# Year 6 Monitoring Report

Roses Creek

DMS Project ID No. 96309

DMS provided the following comments and HDR has replied with the below responses in italics:

DATE: 12-01-21  
CCPV  
YEAR 6  
SHEET  
5  
EEP# 96309

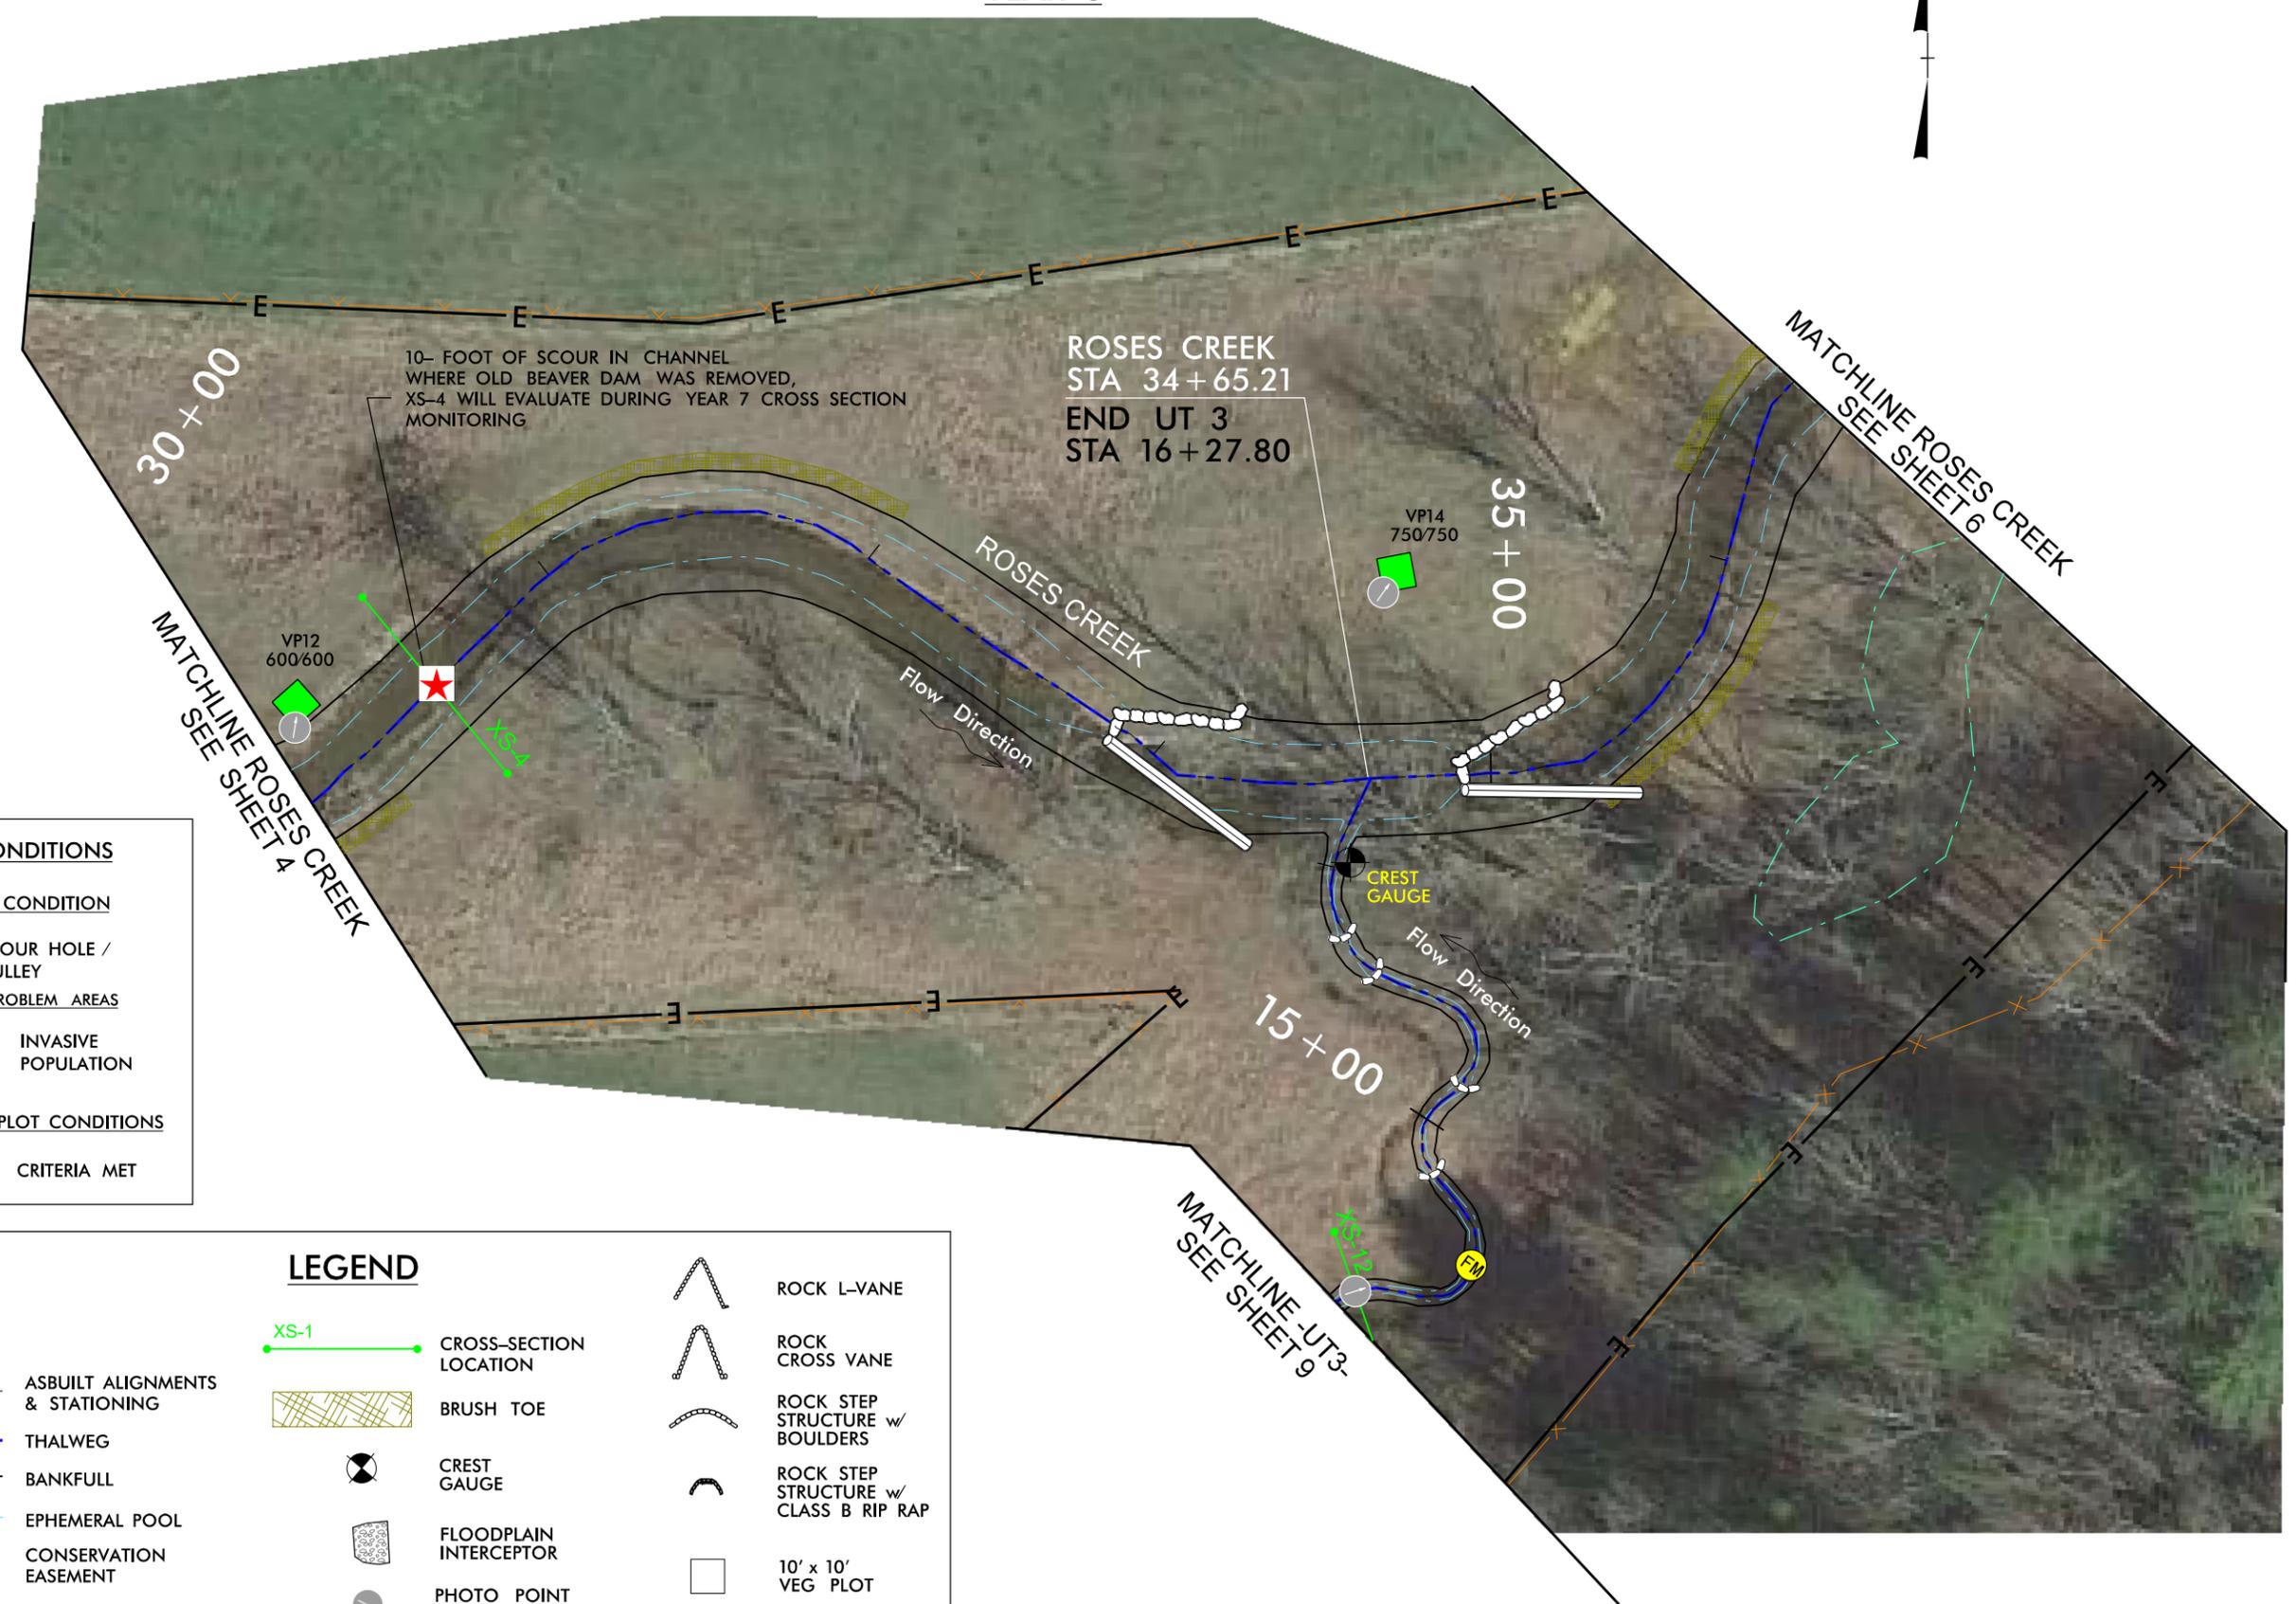
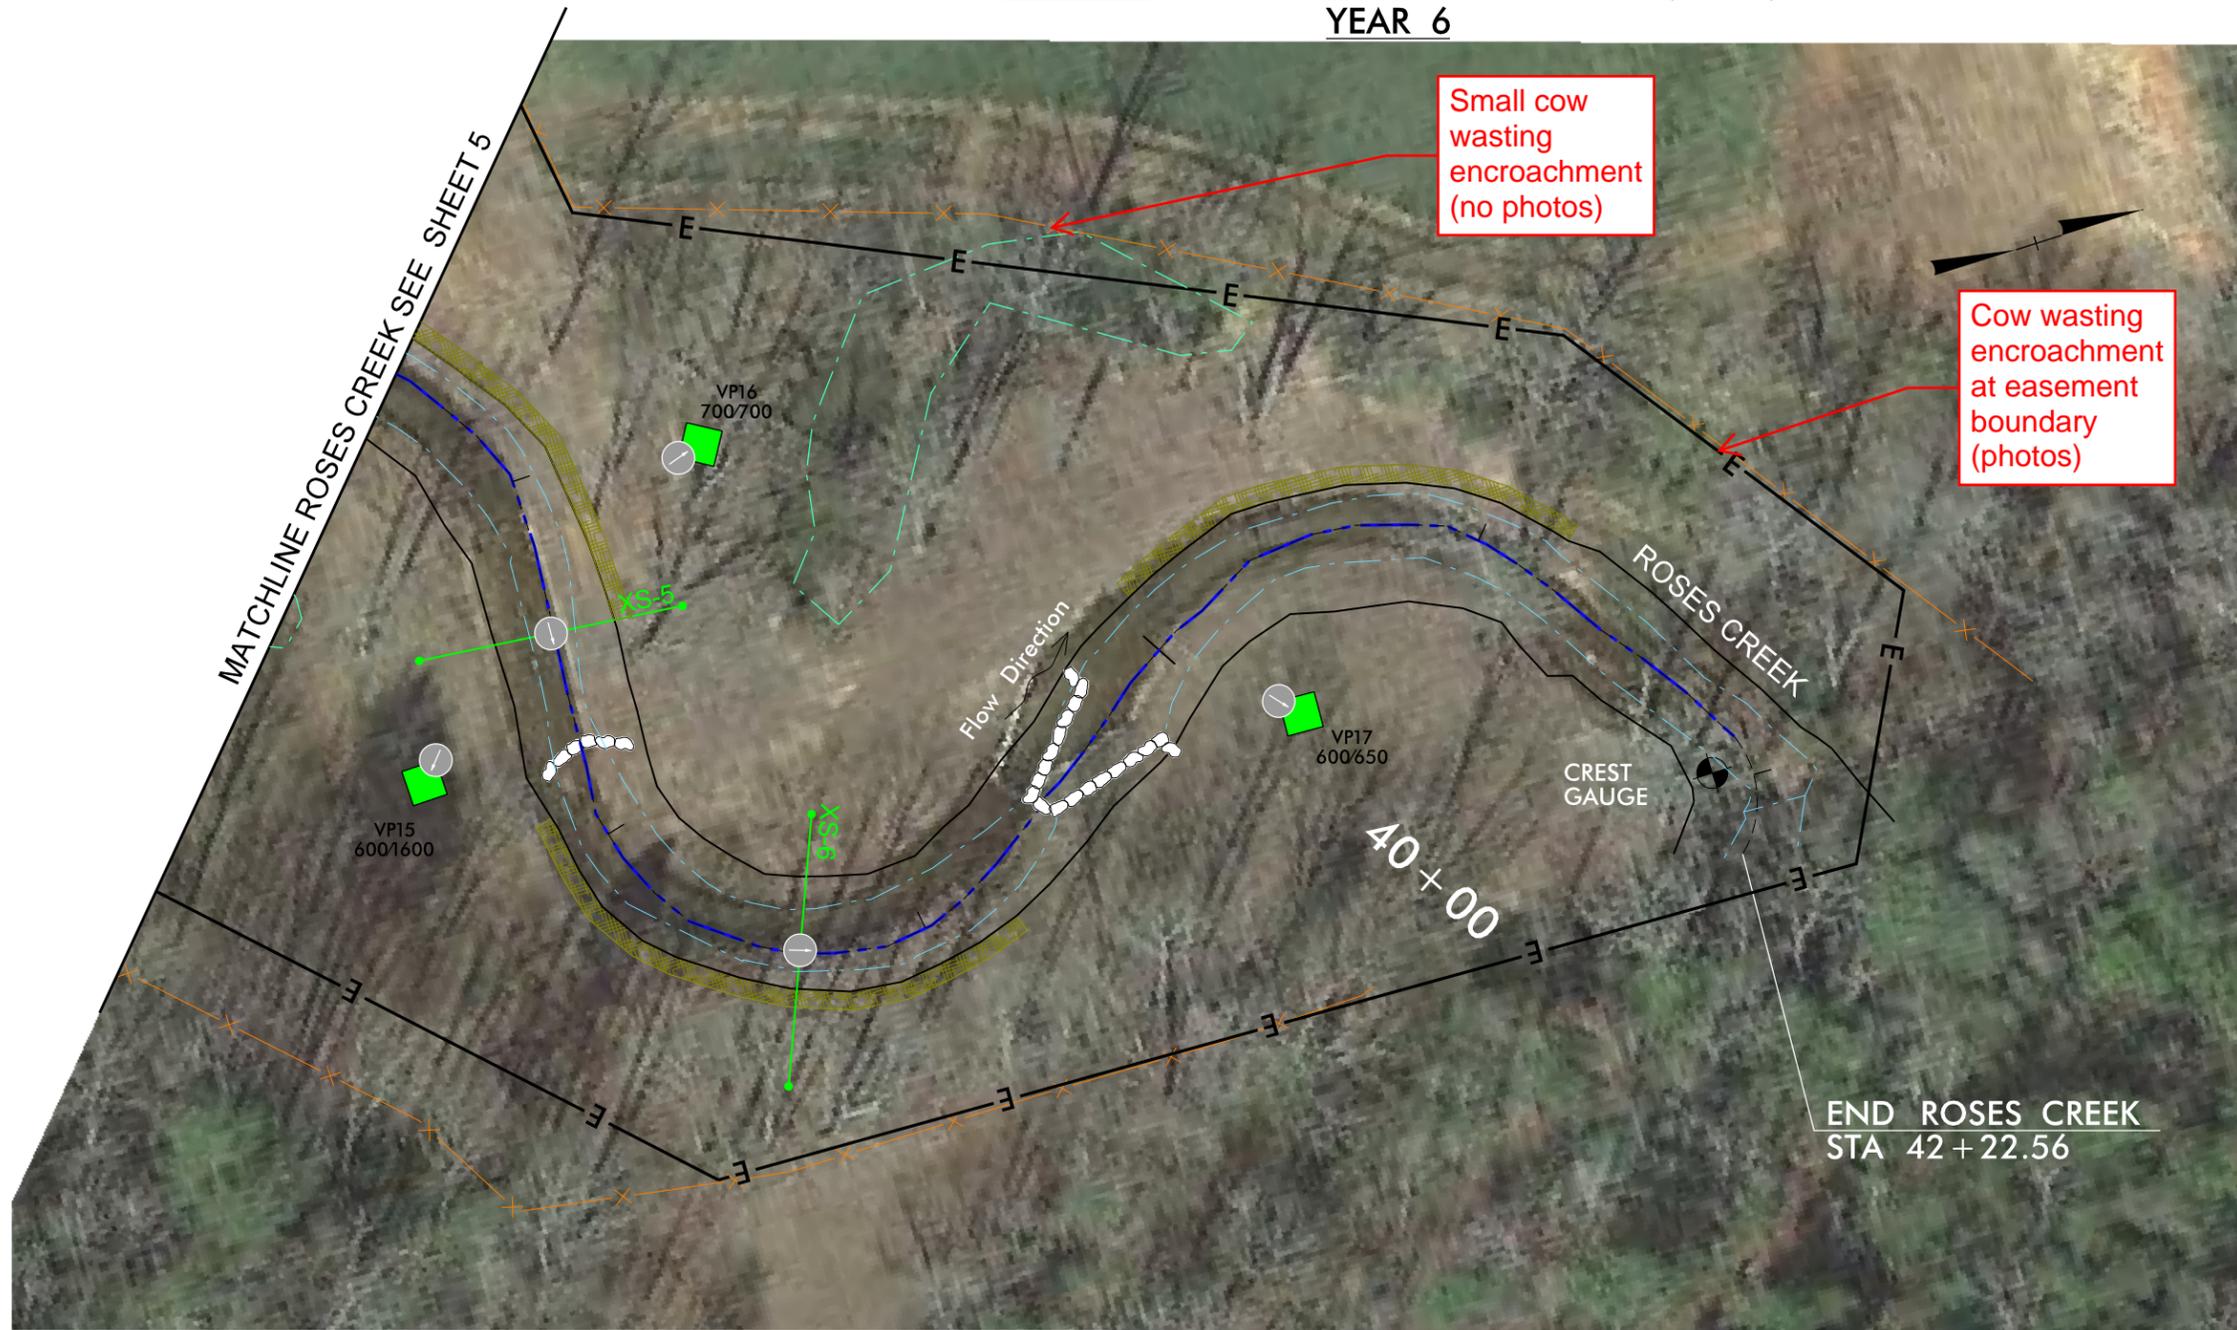
- At the 2021 credit release meeting, the IRT asked about Cross Section 4, which has down cut approximately 1 foot, and asked that HDR look at that cross section in detail in MY6 (2021). Please provide an update and comment on the channel conditions at that location.

- The scoured eroding segment of Roses Creek should have an associated number of unstable segments associated with the reported length – it is currently listed as 0.

*During the credit release meeting in 2020, Cross Section 4 was noted to have down cut approximately 1 foot. Cross Section 4 is in the vicinity of a previous dam removal from 2019 and appears to be redistributing sediment throughout the reach. HDR will carry out cross section monitoring in Year 7 to determine if it has stabilized.*

*HDR added in 10 feet of length in Table 5 to represent Roses Creek downcutting areas around Cross Section 4.*

10- FOOT OF SCOUR IN CHANNEL  
WHERE OLD BEAVER DAM WAS REMOVED,  
XS-4 WILL EVALUATE DURING YEAR 7 CROSS SECTION  
MONITORING

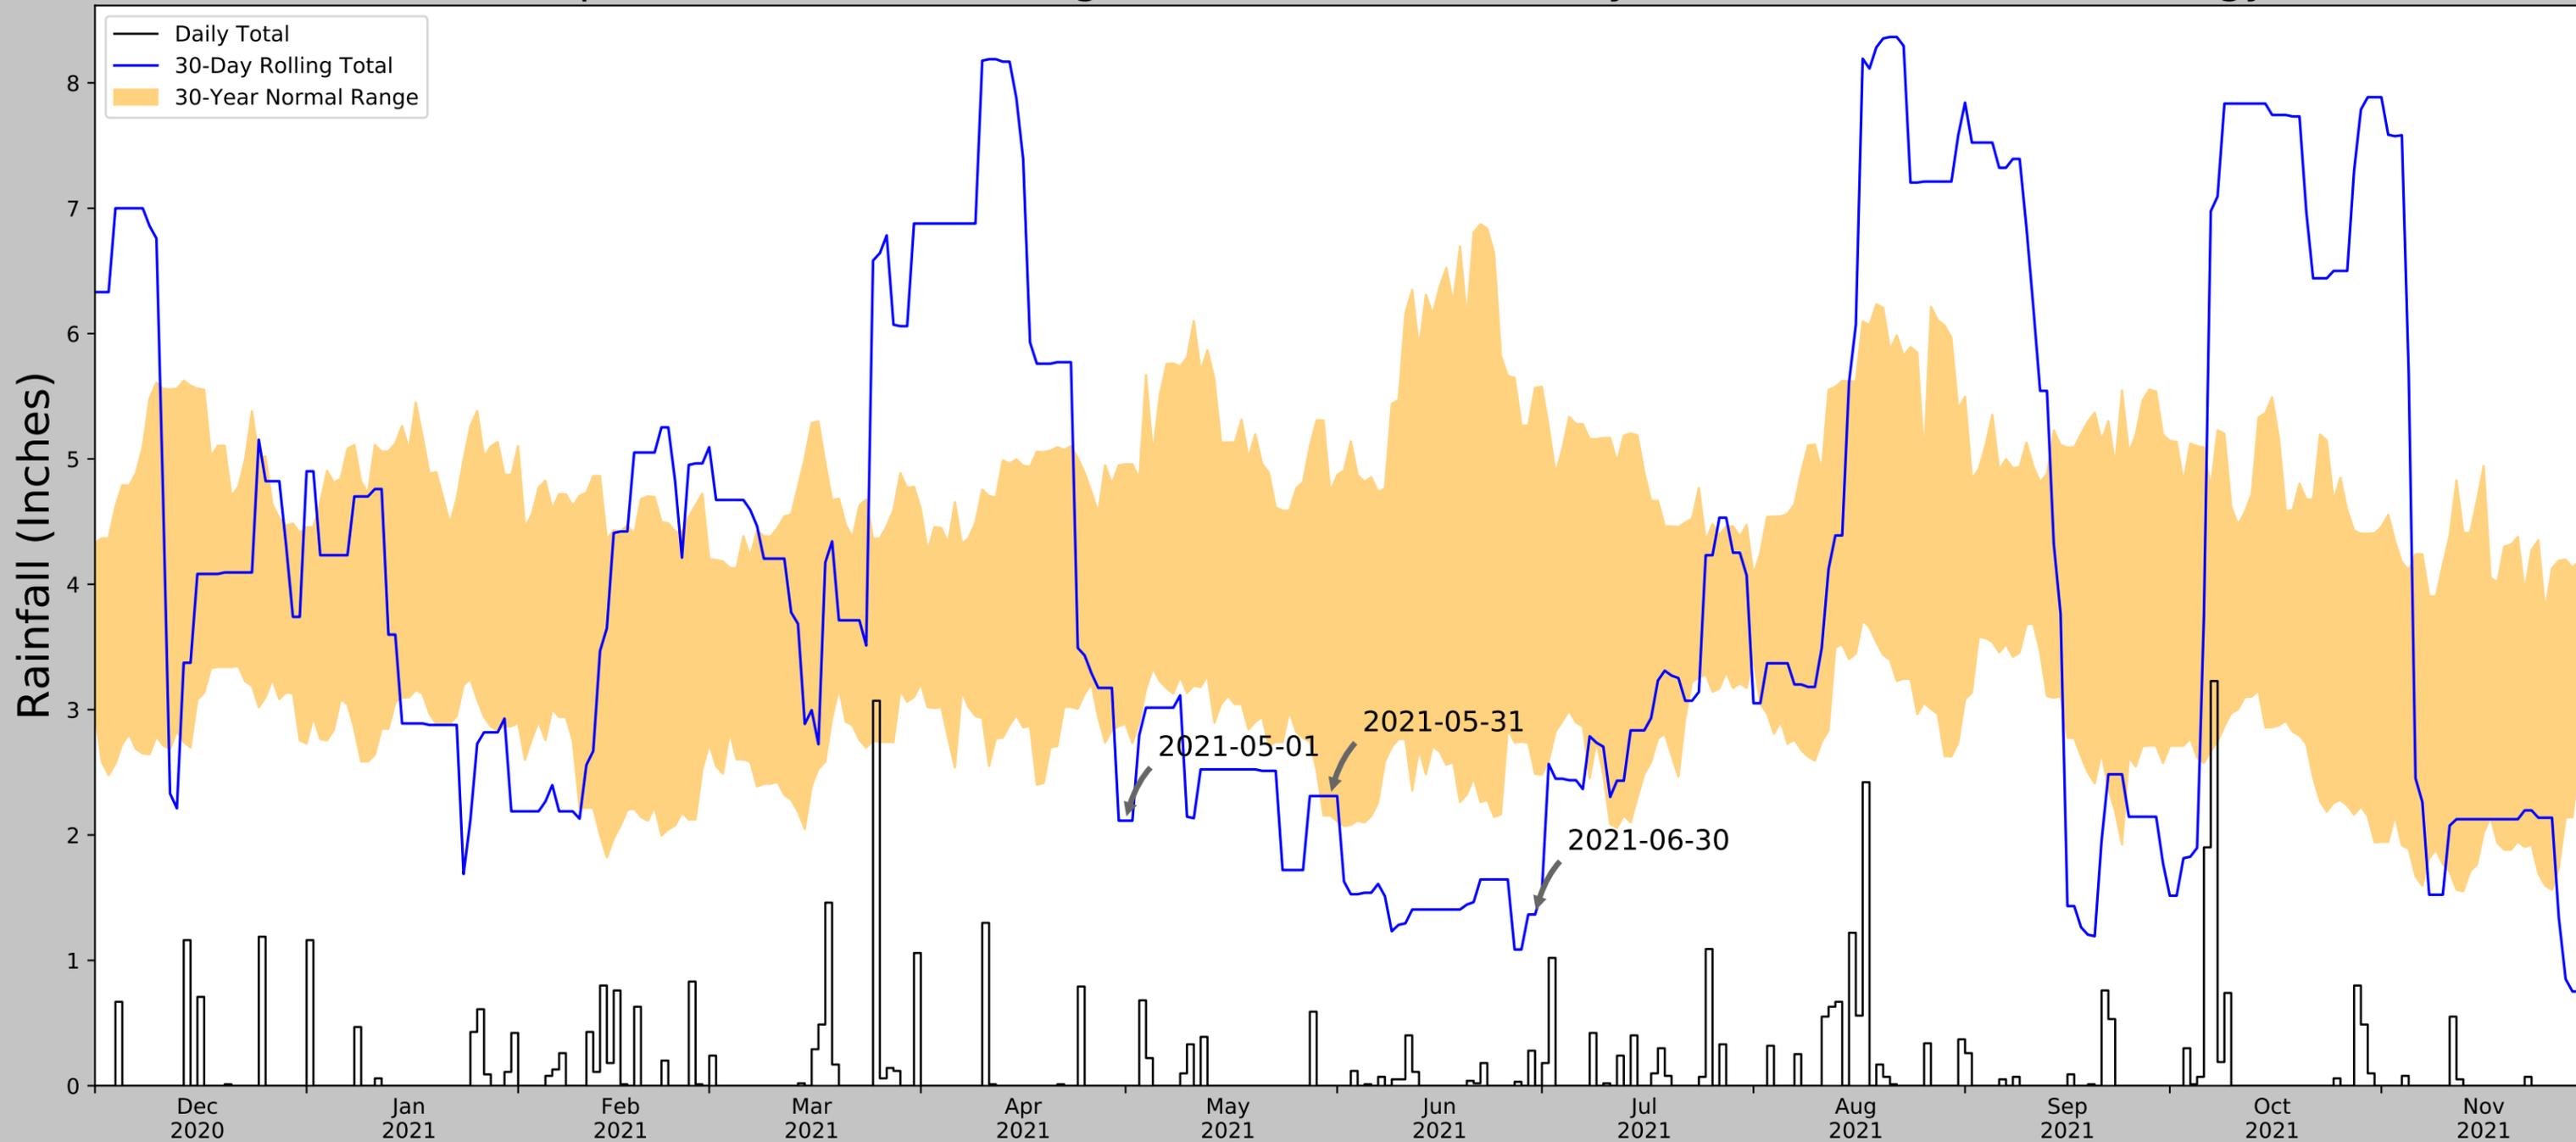
- Please include a figure displaying the 30<sup>th</sup> and 70<sup>th</sup> percentile of monthly precipitation relative to observed precipitation and submit these data.

*HDR has included the USACE Antecedent Tool output showing 30-day rolling total rainfall, large rain events, and the 30-year normal range of monthly precipitation. Between May and June of 2021, it was drier than normal.*
